ADDENDUM NO. 1 TO ALL BIDDERS:

Reference – Invitation for Bid:	IFB #015-0-2025/SNB Yates Elementary School Security Vestibule and Office Addition & Alterations
For Delivery To:	Newport News Public Schools
Bids Due:	March 27, 2025 at 2:00 PM EST

## ADDENDUM NO. 1

#### Yates Elementary School Security Vestibule and Office Addition & Alterations

A6.04

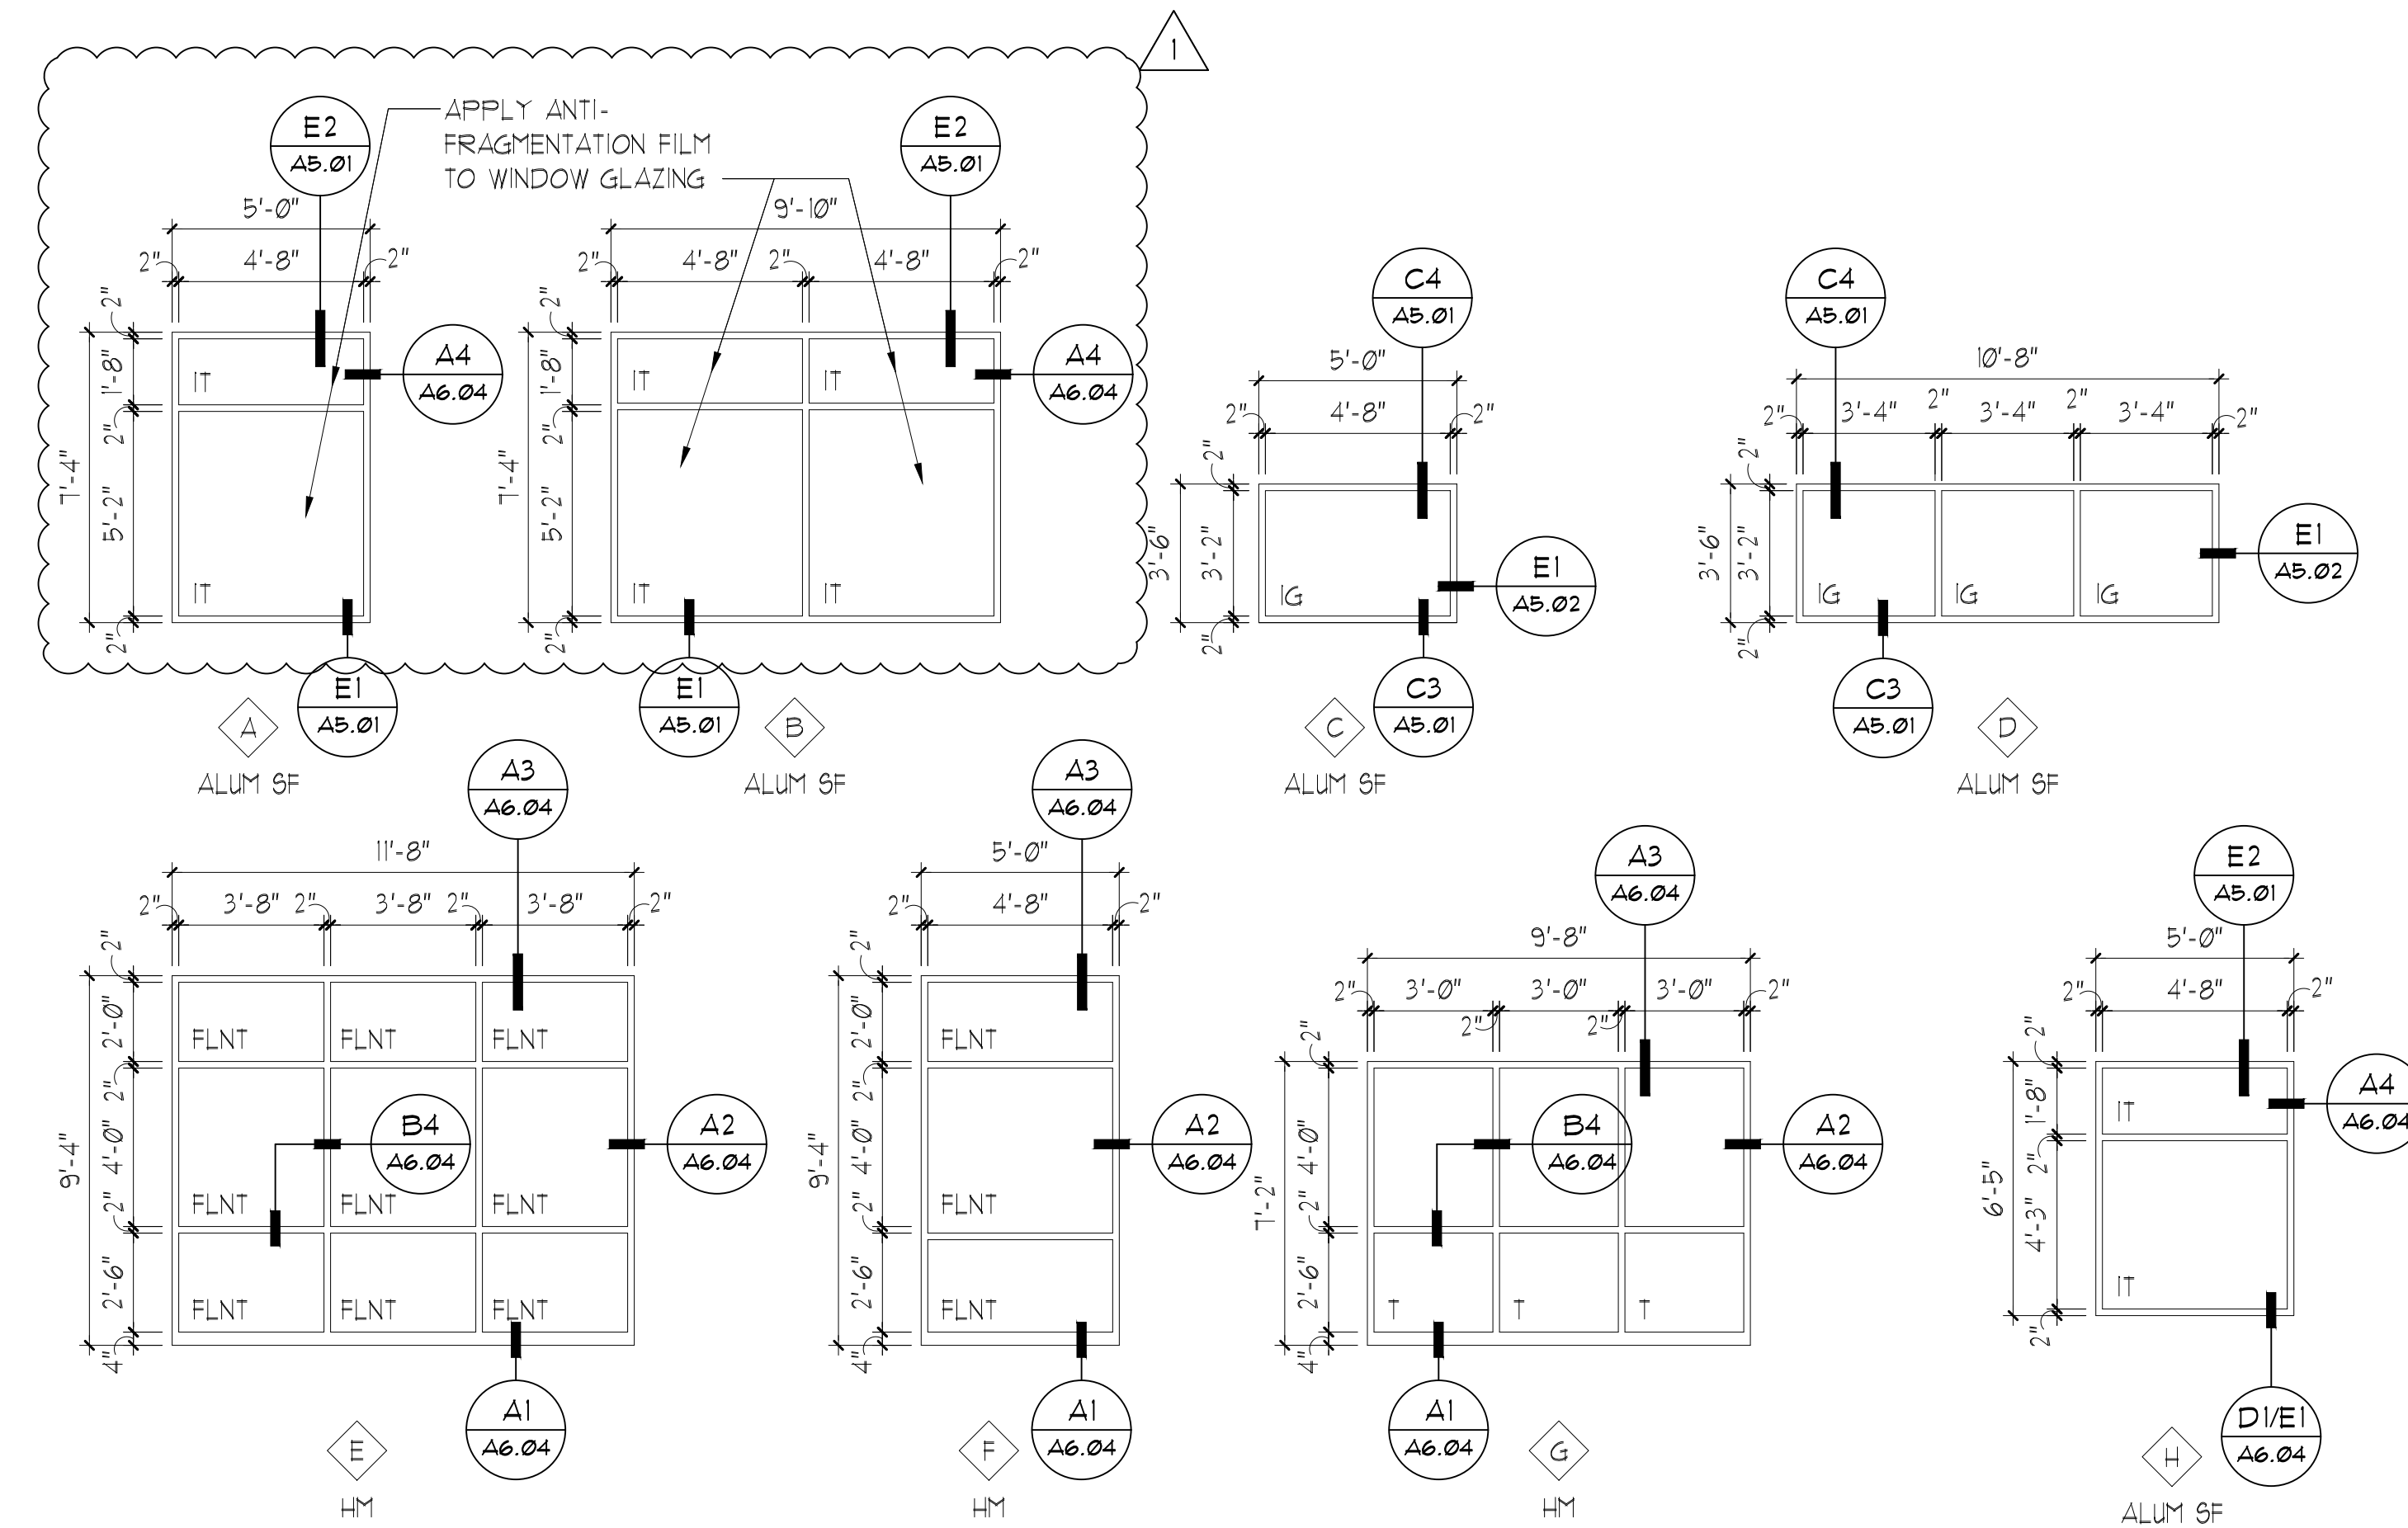
12. Architectural Drawing A6.04: This drawing has been revised as follows:
  - a) Window Schedule:
    - 1) Window Designations 104C and 104D have been included to the Schedule. These were previously shown as "Location Not Found" in the mark column.

- 2) Window Designation 106: The 45-minute fire-resistance rating designation for this window has been omitted.
  - b) Window Frame Types 'A' and 'B': These elevations indicate layout of new exterior windows and frames and are designated to receive application of Anti-Fragmentation Film to glazing, as specified under Spec Section 088723.

18. QUESTION: The first two windows on the window schedule are marked as "space not found." Where and what are these two openings. Is one of them 104A?

RESPONSE: These two windows are interior HM storefronts at the Reception Area where adjoins the Vestibule and the SRO area. We have amended these designations to 104C and 104D respectively so as not to confuse these frames with other door frames having the same number designation. Note that both windows in question have (in original documents) been indicated to receive fire-rated glazing.
